**City of Wichita Standard for**

**Residential Wood Framed Decks**

**Amendments and Changes to the AWC DCA6-09 Document**

**November 01, 2010**

PAGE 8 OF AWC DCA6-09

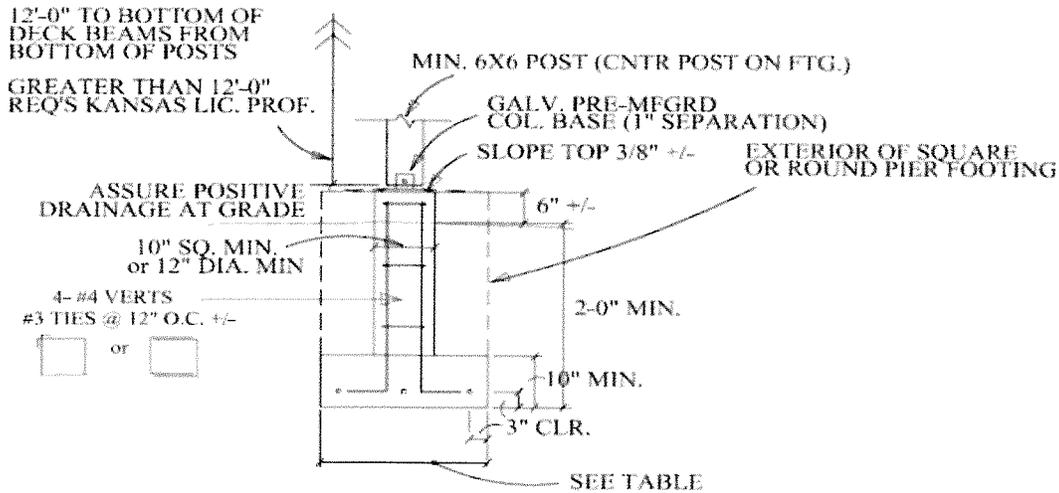
- a. Amend Figure 8 to include the wording: “Notches in posts MUST NOT be overcut.”
- b. Amend Figure 8 to include the wording: “Counter bores are allowed only in the beam; not in the post.”

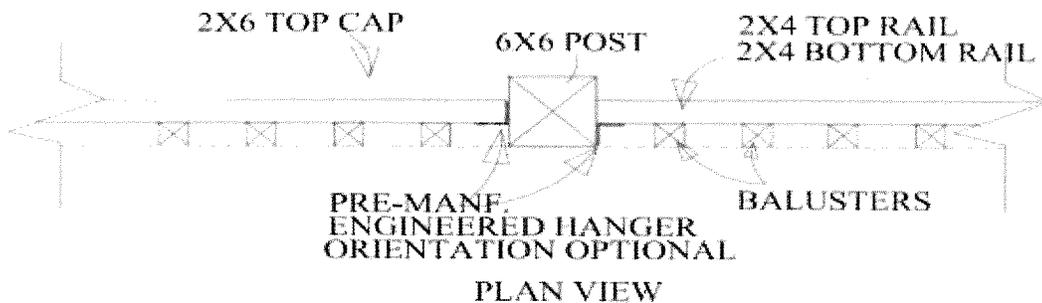
c. Figure 12 shall be replaced by City of Wichita drawing for Typical Footing. With the following: “NOTE: Posts shall not be placed into concrete footings. They shall only be attached by means of approved post base anchors or other method designed and sealed by a Kansas licensed professional. The top of the footing shall extend above finished grade by a minimum of 6 inches.”

NOTE: FOOTING MAY BE INCORPORATED INTO POURED CONCRETE SLAB WITH A MINIMUM 1" OF SEPARATION BETWEEN BOTTOM OF POST AND SLAB.

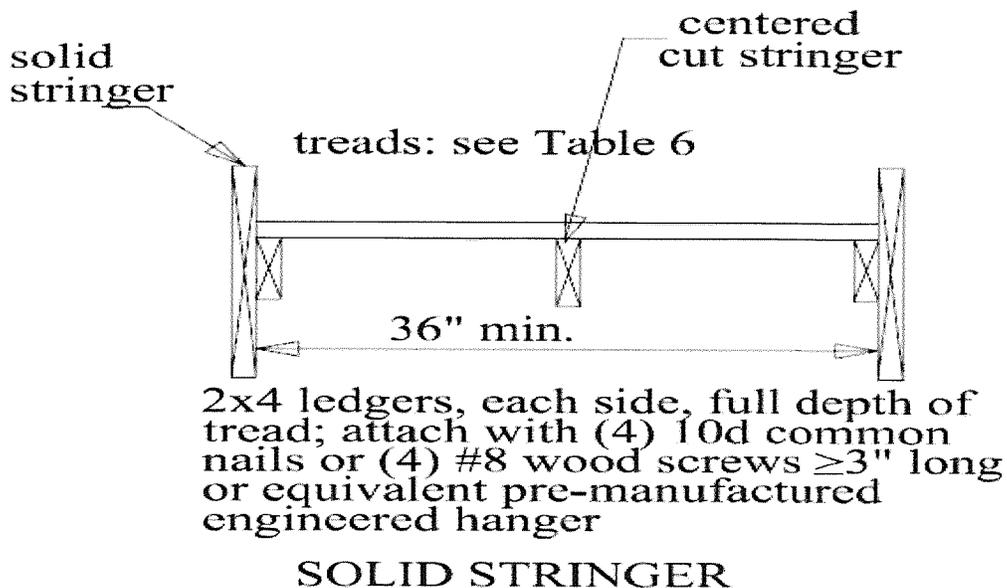
- a. Amend Figure 22 by changing post height to read: “14' - 0" 12' - 0" ” maximum.
- b. “**Guard Requirements**” shall be amended to read as follows:

All decks greater than 30” above grade are required to have a guard [R312.1] meeting the load requirements of [Table R301.5] and the maximum deflection allowance shown in [Table R301.7] - one example is shown in Figure 24. Guards must be mechanically secured to posts with methods other than toe-nails. One method for accomplishing this is shown in the following two (2) illustrations.
